Re: FortisBC Inc. (FBC)

2016 Long Term Electric Resource Plan (LTERP) and Long Term Demand Side Management Plan (LT DSM Plan)

Response to the British Columbia Utilities Commission (BCUC or the Commission) Information Request (IR) No. 1

Figure E-1: Issue Mapping Process

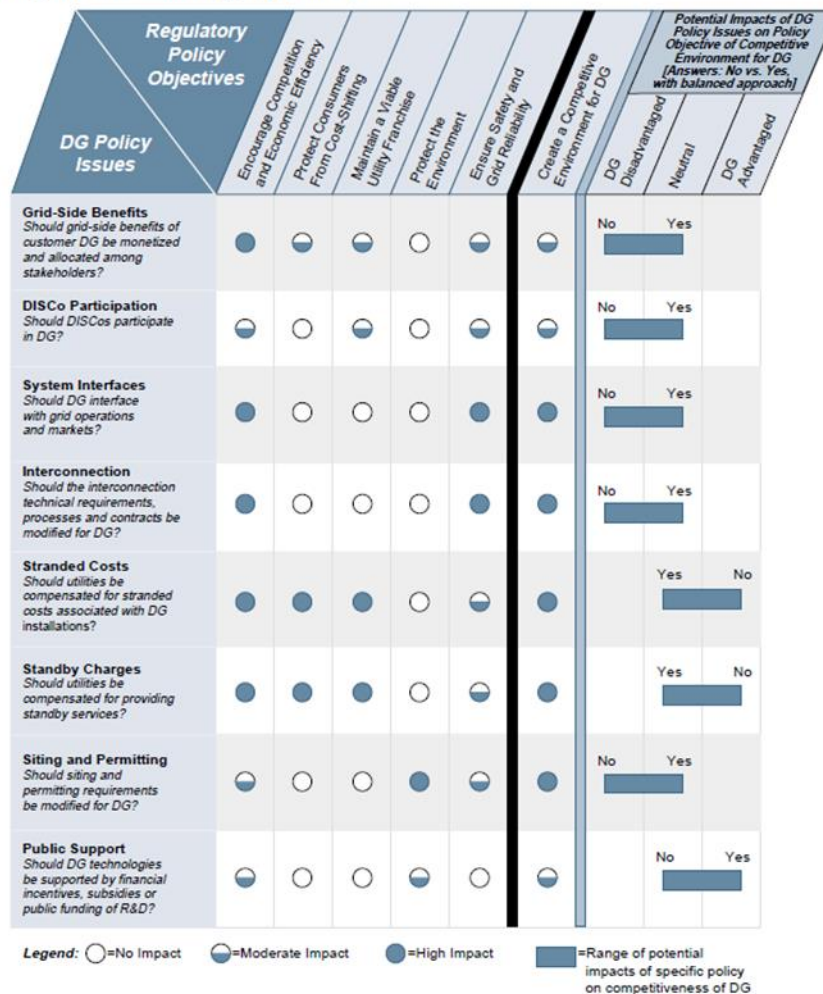
22 10.2 Please describe FBC’s strategy regarding DG. Specifically, for each of the DG
23 Policy Issues described in Figure E-1 of the 1999 Arthur D. Little White paper,
24 does FBC consider that it should advantage, disadvantage or be neutral towards
25 distributed generation compared to other generation? Please also explain
26 whether FBC considers that its strategy should be different depending on the
27 size, type, ownership (e.g. First Nation, community) and location of the
28 generator.

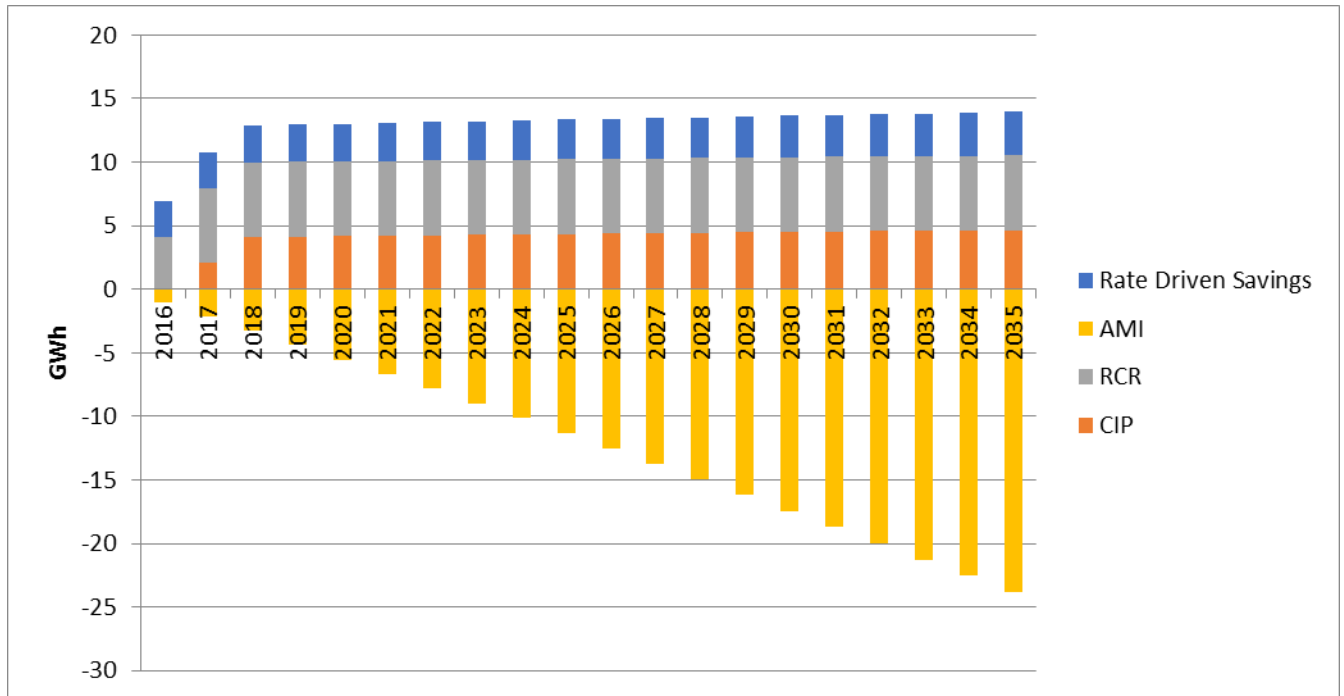
In the course of responding to this IR, FBC identified that Figure E-1: Load Savings 3 in Section 2 of Appendix E of the LTERP is incorrect. A corrected version of Figure E-1 is shown below. Note that the update affects Figure E-1 only. The correct values were used to prepare the forecast.

Figure 1: Annual Energy Load-Resource Balance with PPA Tranche 2

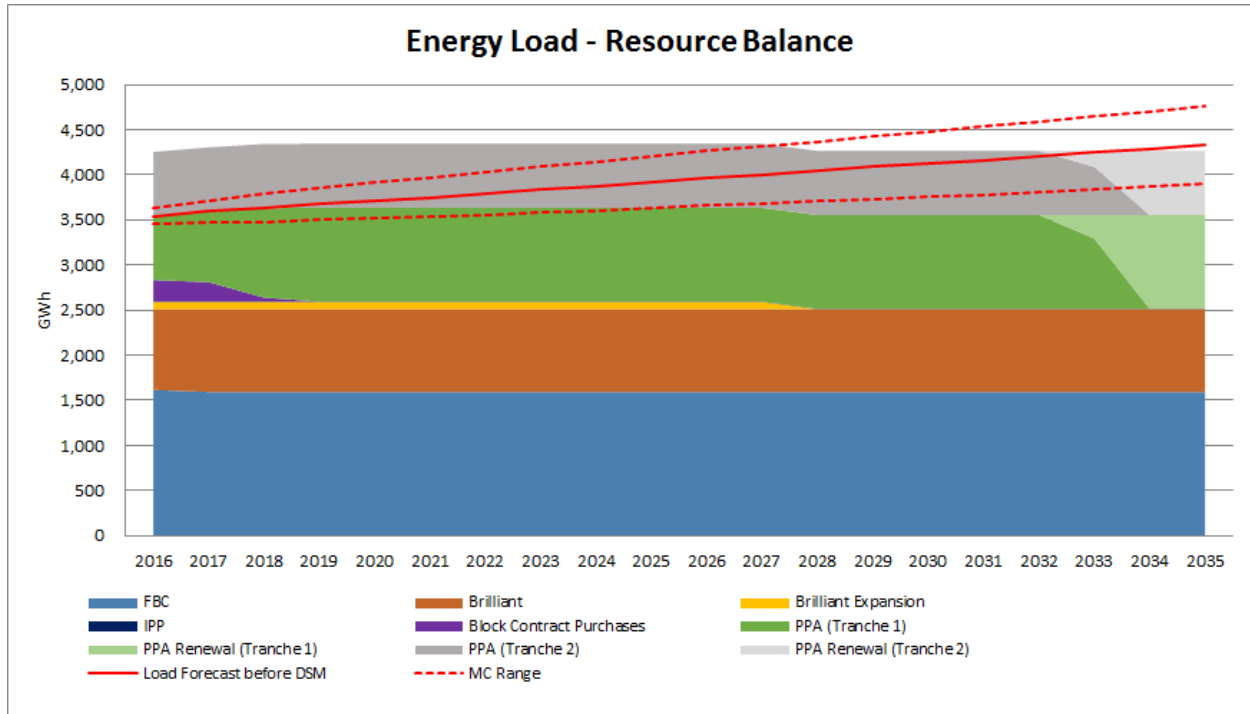
20 24.1 Please provide an updated version of Figure 7-1: “Annual Energy Load-Resource
21 Balance (GWh)”, which includes PPA (Tranche 2) energy in a new colour. Please
22 assume that the PPA Tranche 2 energy price is \$85/MWh, as described in the
23 preamble, from the beginning of 2019.

26 The following figure is an updated version of Figure 7-1 in Section 7.1 of the LTERP with PPA
27 Tranche 2 energy added to the resources.
